SEWAGE DISPOSAL SYSTEM

RE: 13000 Wainwright Rd

RE: Best Available Technology (BAT) Site Plan and BAT denitrification unit required at 13000 Wainwright Road, and other requirements

re: H. P. Hill Property

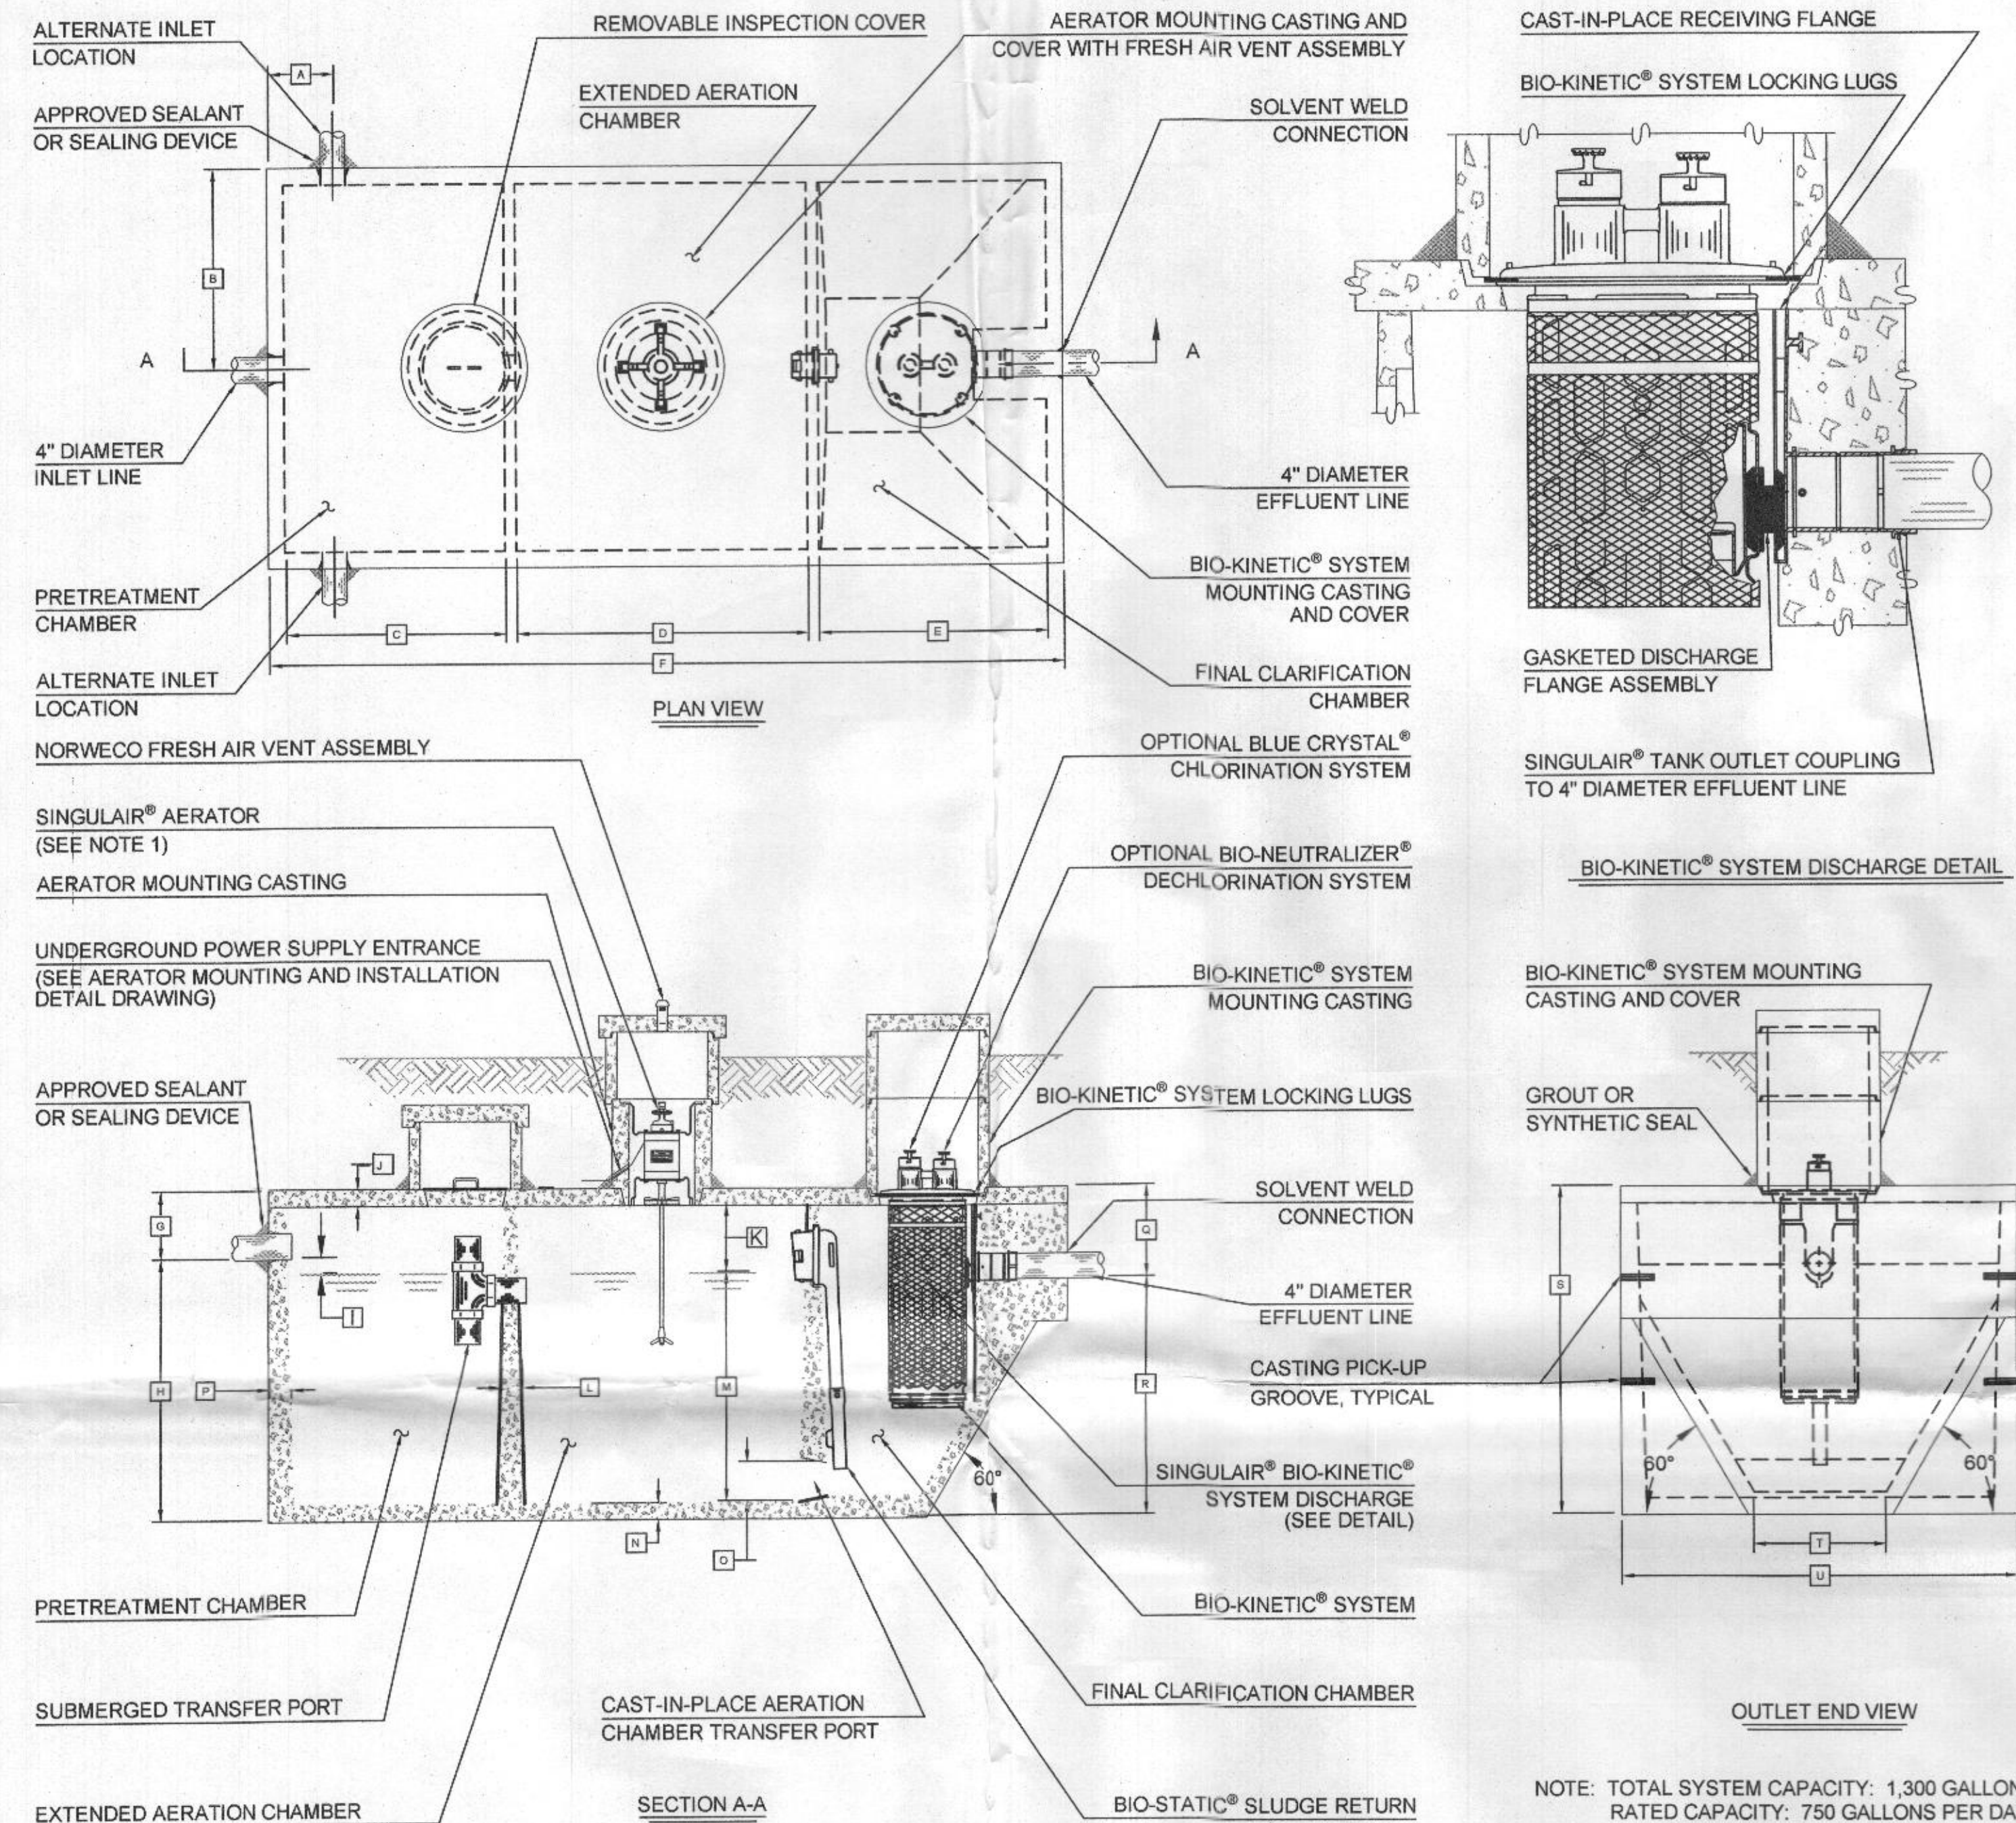
We are in the process of running topography on the H. P. Hill Property. Although the topography is not complete yet, I have plotted what we have shot so far in the area of Lots 1 and 2, and am giving you a copy herewith. It is obvious to me that the stakes we set last week to mark off a suitable private sewage easement for Lot 2 do not accomplish that task. The driveway appears to be in a significant amount man-made cut as it approaches the house, and this cut area was included in the private sewage area we staked out.

On the print of the topography, I have also drawn what I believe to be a better location of a private sewage easement for Lot 2, which does not include any of the driveway cut area, and stays at least 25 feet away from the minor drainage swale on the western side of the property. I request that you review this print and let me know if it is acceptable; if so, we will then make the changes on our Field-Located Perc Test Plat.
